REVIEW OF
KENNEDY RANCH
DRAINAGE
PROPOSAL

Agenda item "h" - "Review of Kennedy Ranch Drainage Proposal" was introduced by City Manager Glaves. Diagrams were presented for Council's perusal.

TENTATIVE MAP
 "KENNEDY RANCH"
 Prepared for: Aladdin Realty
 Lodi, Calif

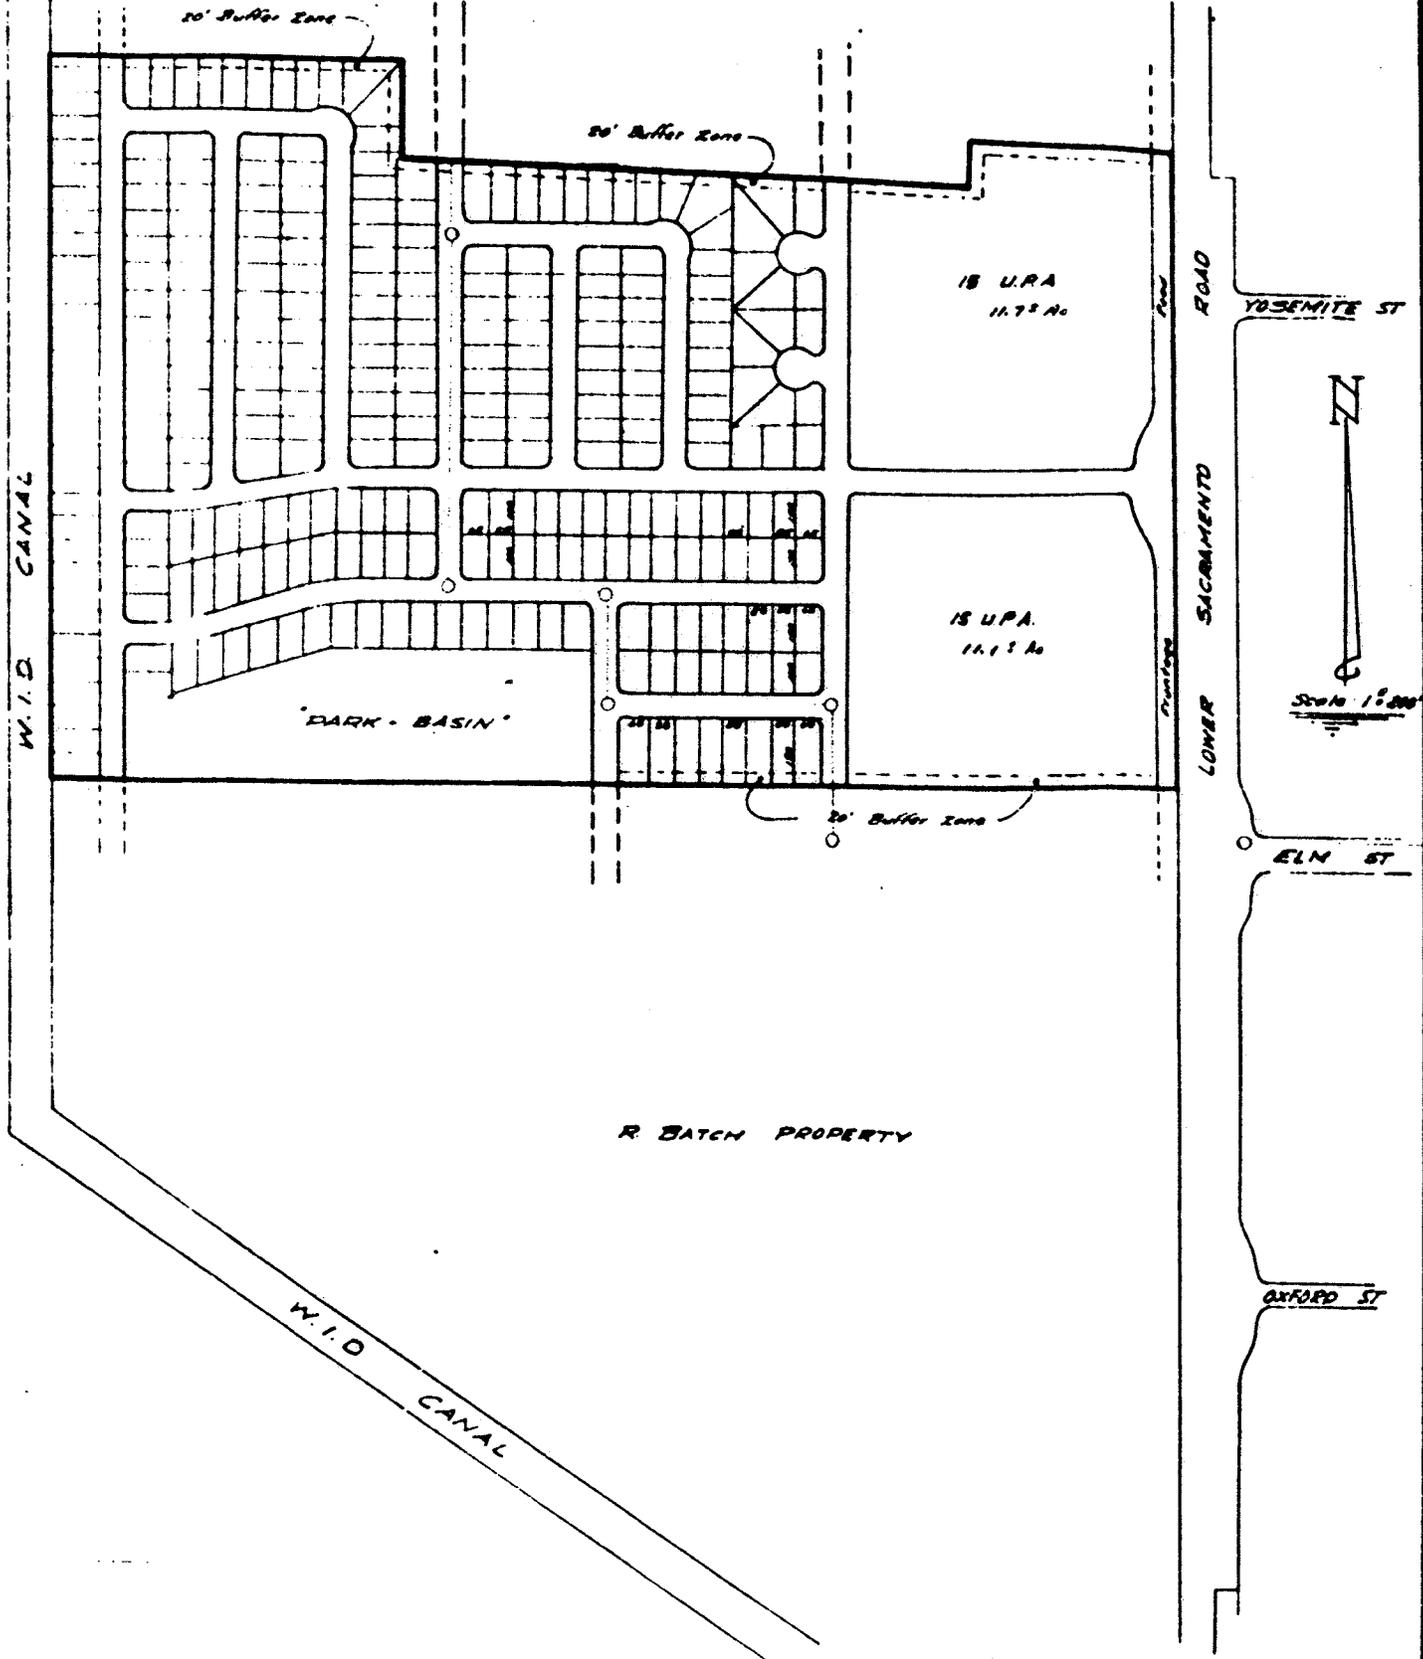
The staff indicated that they had received a submittal from the Kennedy Ranch developers which appeared to satisfy the previous request of the City Council made on August 19, 1981 asking the developers to come back with a plan that included the ultimate basin concept. The development concept presented by staff was as follows:

A basin park would be located in the southwesterly portion of the development and designed to be part of the City's

ultimate basin requirement in the E drainage area.

The basin would be sized to handle the drainage from the proposed Kennedy Ranch development and designed and constructed such that it could be extended southerly as the property to the north or to the south developed.

The developer will construct the park basin to our current drainage basin criteria as it relates to structures, fencing, landscaping, turfing, etc.

The developer will also contract all master drain lines from the park basin to the City's existing system at Elm and Lower Sacramento and all north-south master drain lines necessary to serve future development.

The proposed master drainage facilities constructed by the developer (basin, structures and master plan lines) will be credited against the developer's required master drainage fees.

The dollars required for these master drainage facilities over and above the drainage fees will be fronted by the developer and an agreement will be entered into such that there will be a payback as other properties in the E drainage area develop.

Staff pointed out that the drainage fees for this development would be approximately \$300,000 and the master drainage facilities required would cost approximately \$500,000. Therefore, the developer would be fronting master drainage facilities in the amount of approximately \$200,000. Staff pointed out that with concept approval, an amendment would be made to the already certified EIR and that the project would be then again reviewed by the Planning Commission and the amendment to the EIR would come back to the Council for final approval.

It was also pointed out that the developer was proposing a 20-foot buffer zone on the north end along the north and south properties. This buffer zone would provide for 20 feet of additional landscaping and all lots affected by the zone would have an additional 20 feet in depth or width.

Council further tacitly concurred with the "Buffer Concept" heretofore described.

On motion of Councilman Katnich, Pinkerton second, the "Basin Concept" heretofore described was approved by the City Council.
